## Solicitation Addendum

Addendum No.: 2  
Solicitation No.: 22-R078489BB  
Solicitation Title: Manatee County Area Transit (MCAT) Onboard Camera System  
Addendum Date: February 22, 2022  
Procurement Contact: Brooke Baker, CPPB, Procurement Team Leader

**EXHIBIT 5, DVR LOCATION PICTURES**

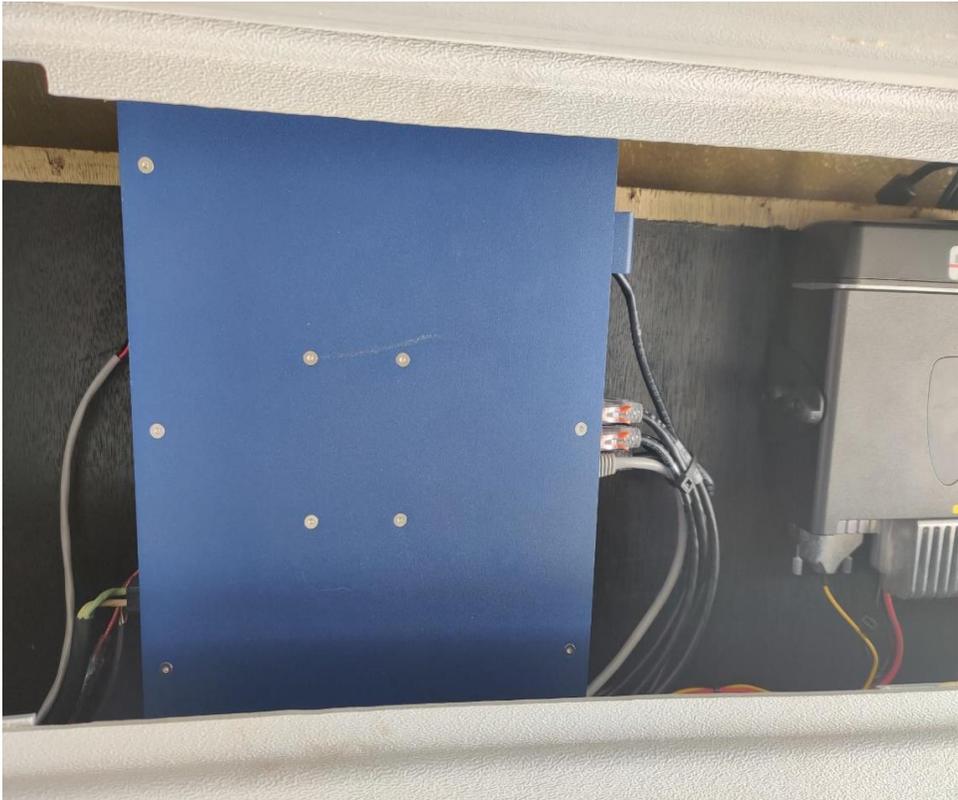
- A. Year/make/model for each of the 38 Fixed-Route/Trolley buses as well as the 40 Paratransit buses?**
  - B. Current mounting location of the Apollo DVR on each bus year/make/model (or pictures if available)? Are any of these existing DVRs (e.g., in paratransit vehicles) mounted in a custom Apollo lockable enclosure?**

- A. Refer to Exhibit 4 issued with this Addendum.
- B. Refer to Exhibit 5 issued with this Addendum. MCAT does not use Apollo lockable enclosure.
- C. The awarded Consultant shall verify the exact available space (length x width x height) for each new NVR to be mounted once each existing DVR is removed. For fixed-route/trolley vehicles, MCAT has a large cabinet behind the driver's seat to house ITS equipment, including the DVR that measures 44x22x20. For paratransit vehicles, the NVR can be mounted above the driver's seat enclosure that measures 16x44x6 for Ford vehicles and 14x40x11 for Chevy vehicles or underneath the passenger seat for Ford transit vehicles.
- D. Refer to Exhibit 4 issued with this Addendum.
